SECTIONS A & B

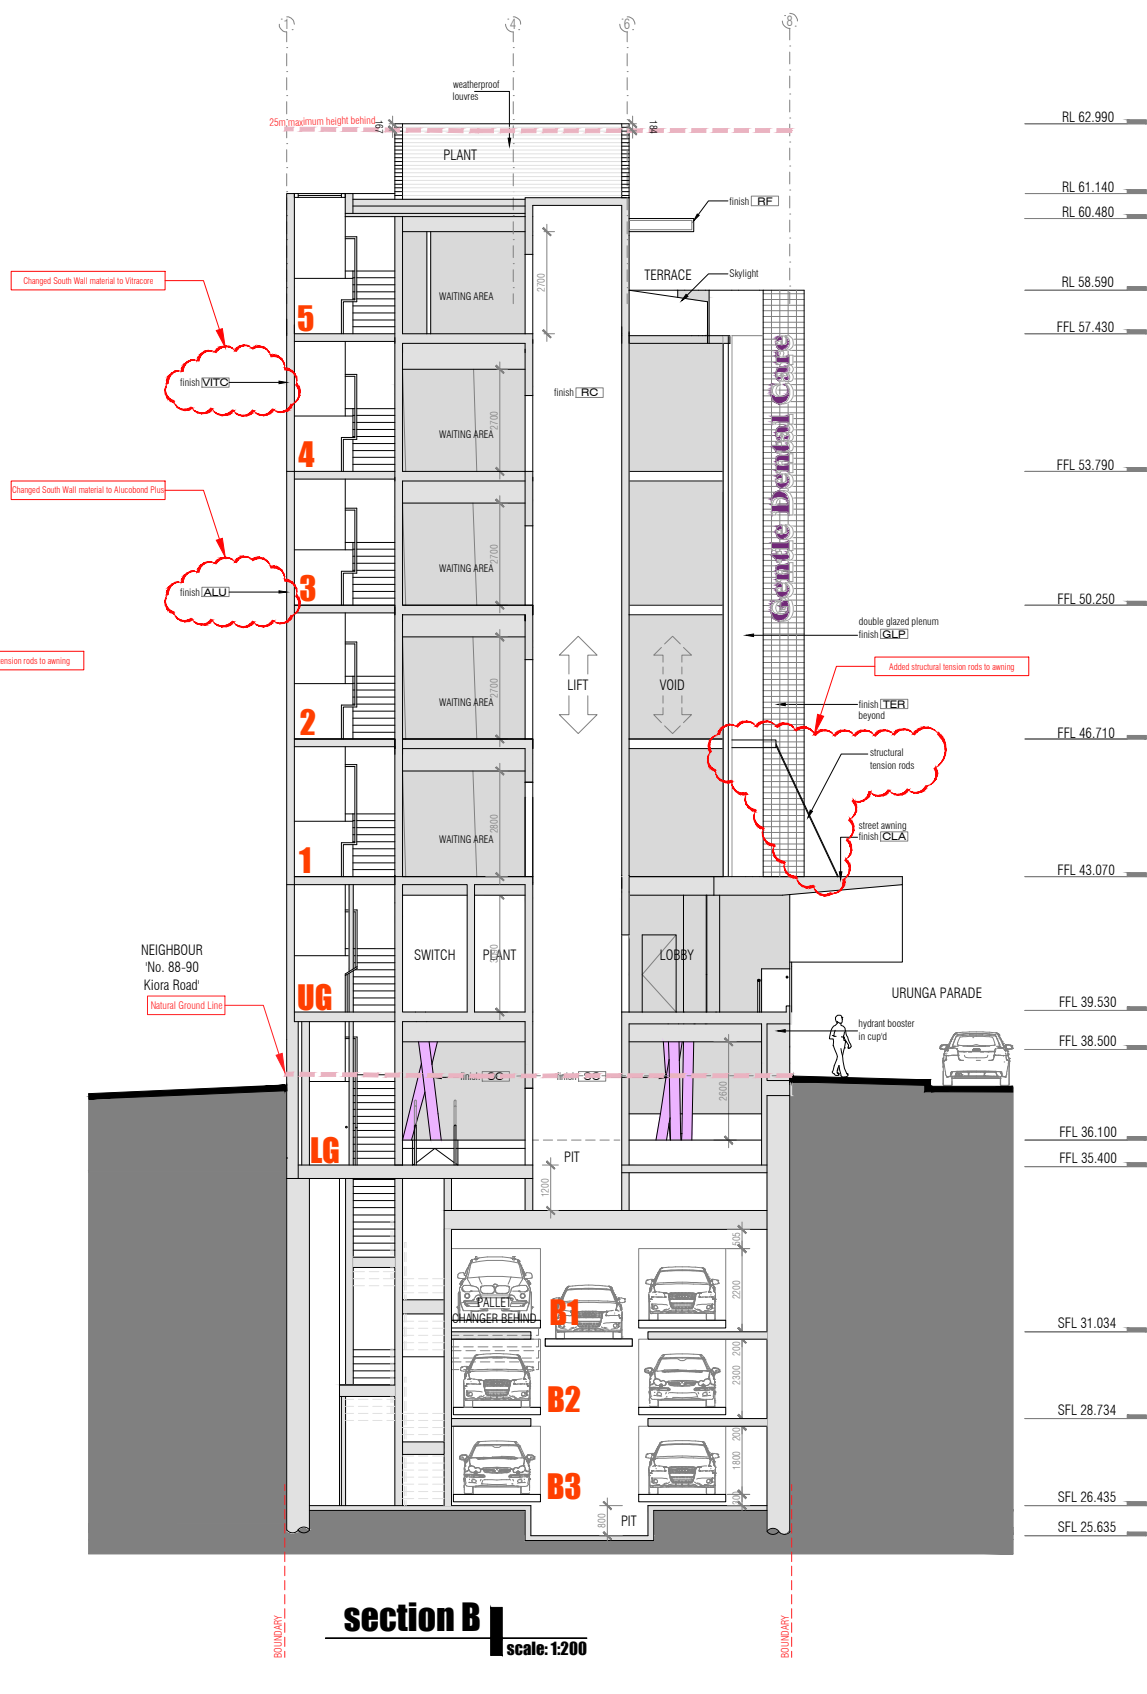
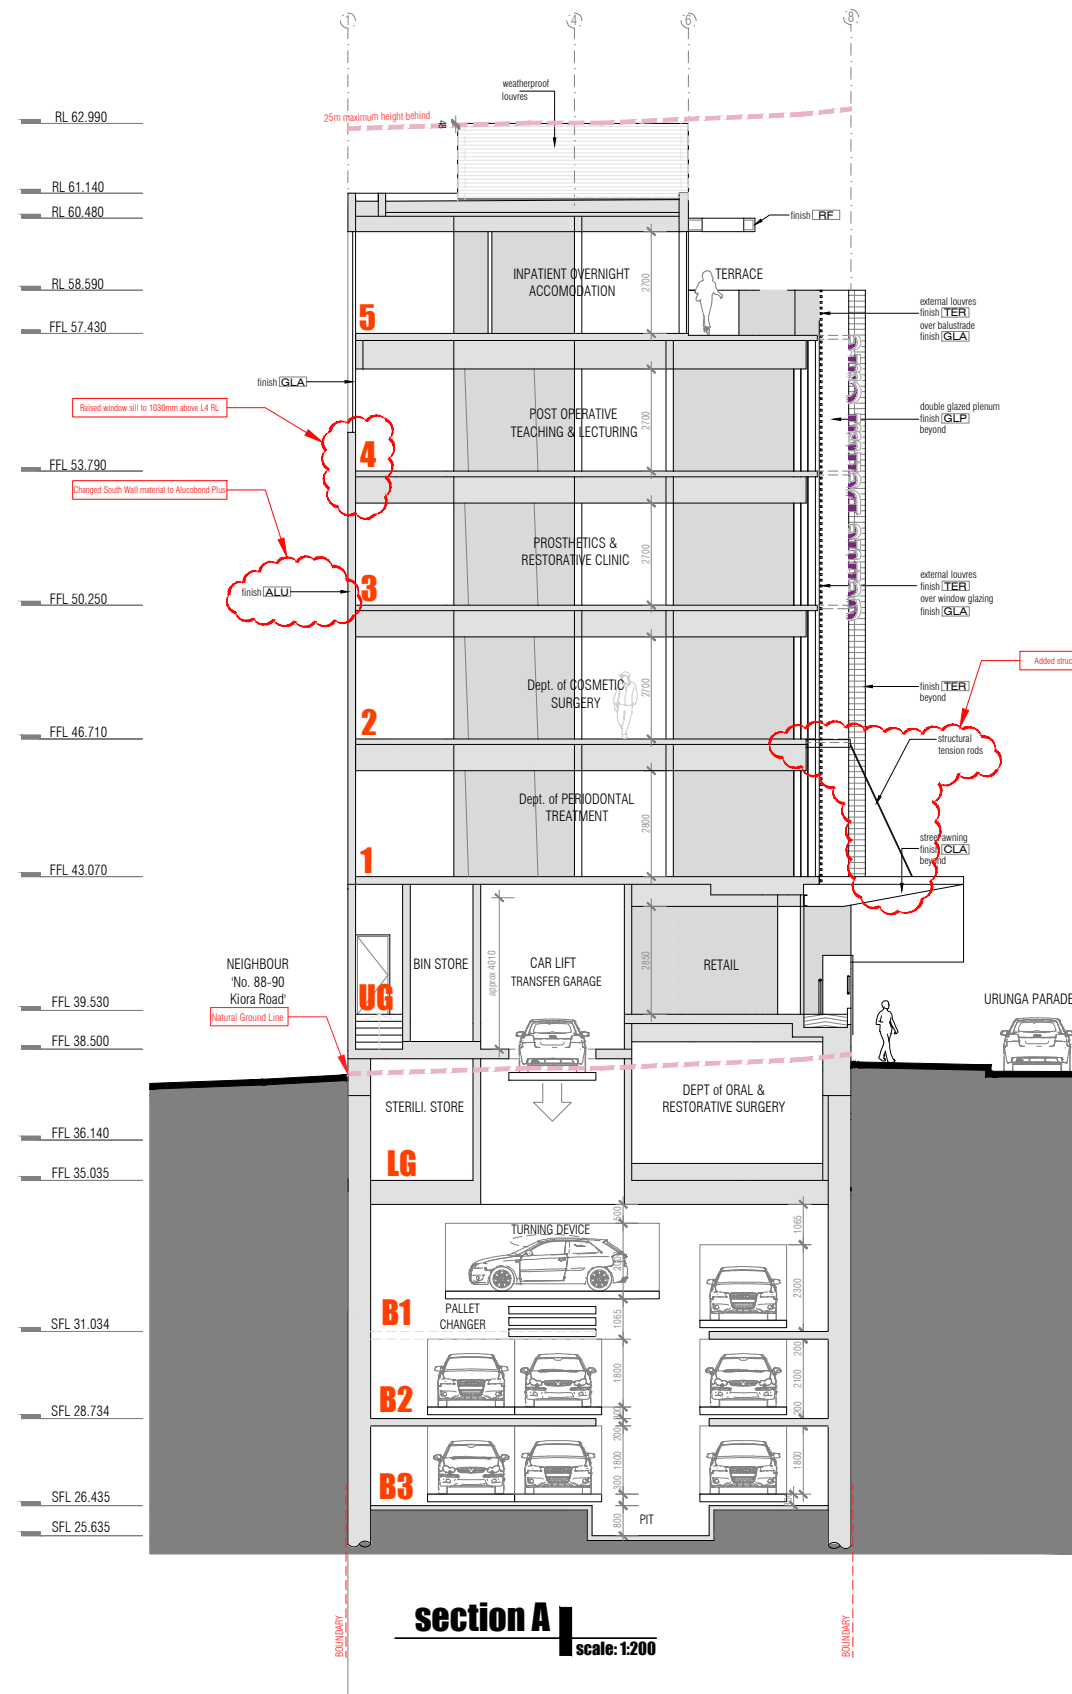
PATTERNED FORMALINE CONCRETE FINISH REPLACED TERRACOTTA

amendments	date	description
0	28/11/2017	1. Lower ground floor level lowered due to council's required new footpath level.

amendments	date	description
1	28/11/2017	2. Added awning tensile rods by structural engineer.

amendments	date	description
2	28/11/2017	3. Amended south wall to Alucobond/Vitacore finish.

amendments	date	description
3	28/11/2017	4. Raised window sill on Level 4 South wall.

amendments	date	description
4	28/11/2017	5. Deleted 1 internal steel column on West Elevation.

amendments	date	description
5	28/11/2017	6. Amended air plenum proportion and image.

amendments	date	description
6	28/11/2017	7. Amended Urunga Parade Entry staircase profile.

amendments	date	description
7	28/11/2017	8. Amended shape of column at Kiara Road entrance for structural support.

amendments	date	description
8	28/11/2017	9. Added signage at Kiara Road awning.
